Comments Primarily Related to the EMDF Waste Acceptance Criteria fact sheet
Due DOE June 7, 2022

Subject: Comments primarily related to the Waste Acceptance Criteria fact sheet

2.2.4 Radionuclide Mobility

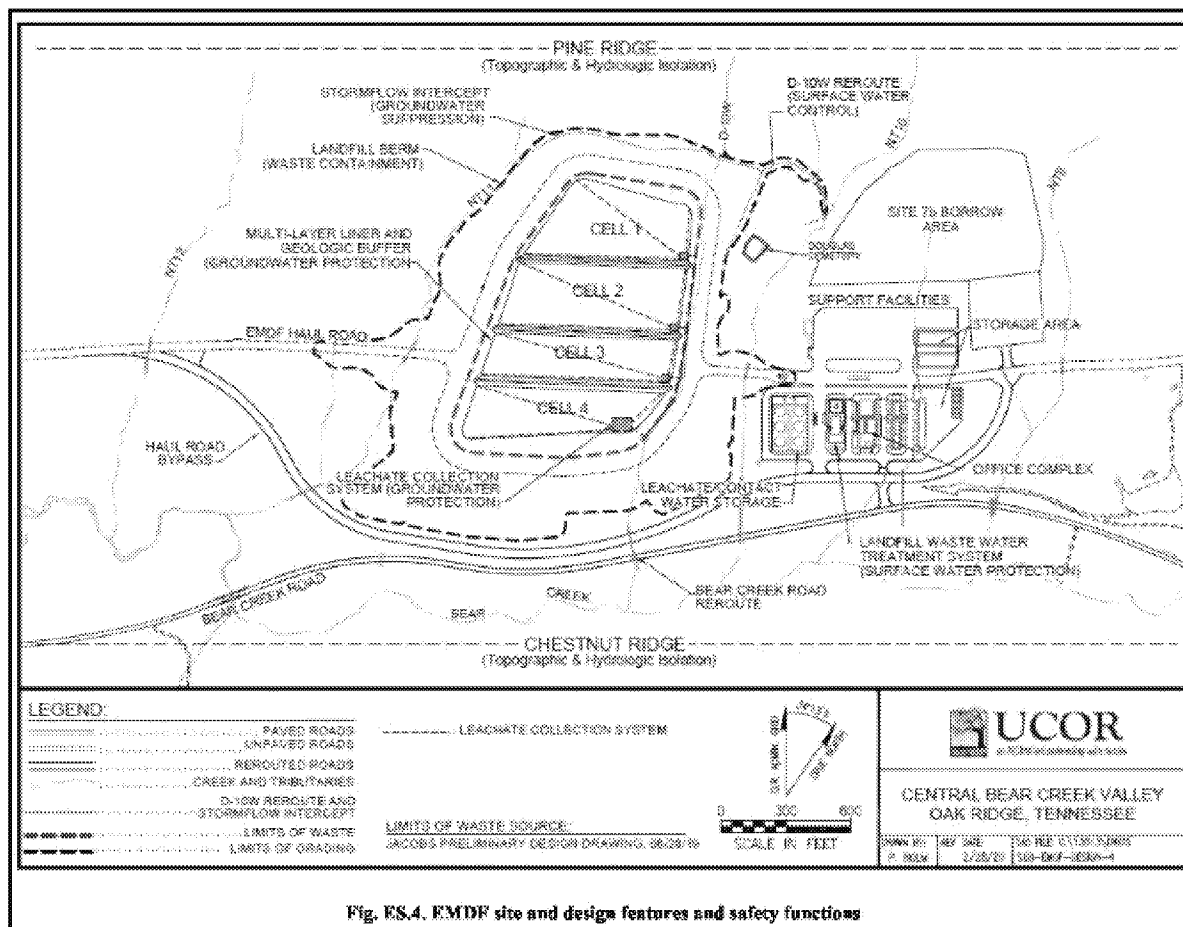
8. Neptune and Company’s comments include the following. Among other things, this discusses mobile forms of uranium. Waste Acceptance Criteria including inventory limits are needed for uranium, and its various isotopes and progeny, and uranium metal. It is unclear what other radionuclides were screened out in the Performance Assessment due to relatively large assumed *k_d* values and assumed negligible cover degradation. This should be reevaluated, and other radionuclides added to the analytical Waste Acceptance Criteria to protect groundwater and fish consumption.

- *The PA and CA evaluate risks from only a small handful of constituents proposed for disposal: H-3, C-14, Tc-99, and I-129. Many other potential contributors to radiological dose and risk have been practically omitted from the analysis due to a combination of relatively large assumed *K_d* values and an assumption of negligible degradation of the performance of the engineered cover over both 1000- and 10,000-year periods of assessment. The most significant omission from the analysis is evaluation of relatively mobile forms of uranium, and its various isotopes and progeny.*

- *In dismissing other radionuclides from the analysis, their progeny are dismissed as well. Some of these progeny might have a low retardation factor and high dose effects, and should be considered. For example, the decay chain of U-238, even when limited to progeny with half-lives over 5 years, includes U-234, Th-230, Ra-226, Rn-222, and Pb-210. Radon-222 is a noble gas (with zero retardation) and although omitted from dose analyses in air, it can contribute strongly to doses by other exposure pathways and deposits another strong dose contributor, Pb-210 (and its progeny), in locations near the ground surface. Once U-238 progeny achieve secular equilibrium, doses from what was once purified U-238 can increase by orders of magnitude. The issue of the exclusion of doses from progeny (and specifically external doses from radon progeny) is not addressed in the R2 PA.*

- *The PA models a variety of materials using the same *K_d* values, which is not in keeping with common practice. Even the older Baes et al. (1984) and Sheppard and Thibault (1990) references provide different values for different materials. Approximately 50% of the waste is expected to*

consist of debris with characteristics very different from those of local soil. Critically, this statement (R2 PA Executive Summary, p. ES-10) may not be correct: "Under a long-term performance scenario, contaminant retardation in the vadose zone beneath EMDF and within the saturated matrix of the fractured rock at the CBCV (Central Bear Creek Valley) site serve disposal system safety functions by delaying and attenuating impacts of radionuclide release at potential groundwater and surface water exposure points." Retardation is reduced in the fracture-dominated flow of the saturated zone. By applying the same Kd values in the fractured rock zone as at other locations in the model domain, longterm performance is overestimated. Accordingly, this approach understates long-term contaminant transport and dose consequences.

- *Neptune's supplemental RESRAD modeling indicates that near-term (<1000 years) and long-term performance is substantially poorer than that shown in the PA when substituting recommended Kd values (geometric mean) for clay soil type (most analogous to shale) from the RESRAD DCH, Table 2.13.3 (Yu et al. 2015) for the base case values used in the PA. Base case Kd values are lower (more "conservative" inasmuch as contaminants move more quickly via water pathways) than the RESRAD DCH Kd values for elements with relatively large Kd values. However, the opposite is true for uranium and the more-soluble elements hydrogen, carbon, and technetium, and it is these more-soluble elements that are responsible for water-pathways doses. The influence on modeled future doses from using these lower Kd values is particularly evident if infiltration rates exceed the 1 in/yr "degraded condition" value assumed in the PA.*

9. The above comment on kd values and the comment on kd values in comments on the Water Quality Protection for Bear Creek fact sheet shows the effect of assumed kds in the EMDF Performance Assessment. WAC to protect groundwater use and ingestion of fish pathways should be calculated using kd values from ORNL Risk Assessment Information System, ANL RESRAD, and other authoritative sources.
